JONATHAN R. BROOKS
BUREAU CHIEF
ELEVATOR AND AMUSEMENT DEVICE BUREAU

CROSS SECTION OF SIZZLER SEAT MOUNTING

SIZZLER

Re: Sizzler Internal Steel Frame Middle Bolt.

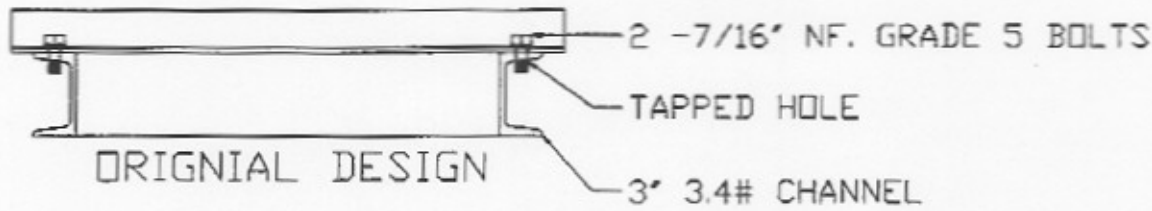
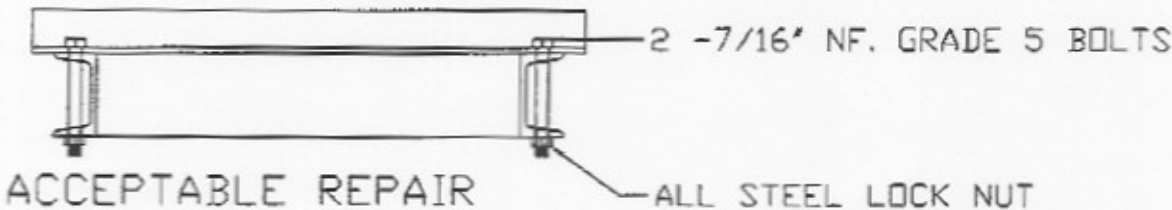
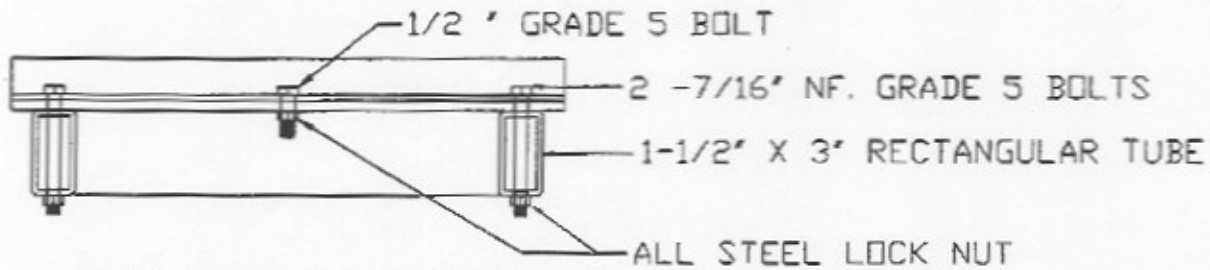
There are rides that have been modified by the customers over the years. Some of the changes we have only found out this last fall. There are units that the frames are welded to the sweeps and older rides that have added the third bolts.

OK IF FULLY INSPECTED ANNUALLY.
MONTHLY CHECK THAT BOLTS ARE NOT LOOSE.

MONTHLY CHECK THAT TAPPED BOLTS ARE NOT LOOSE.
FULL INSPECTION ANNUALLY

FULL INSPECTION ANNUALLY

At this time it is not required to add the middle seat iron attachment bolt to the seat iron frames on the older Sizzlers.

If a customer does add the bolts it is acceptable also.
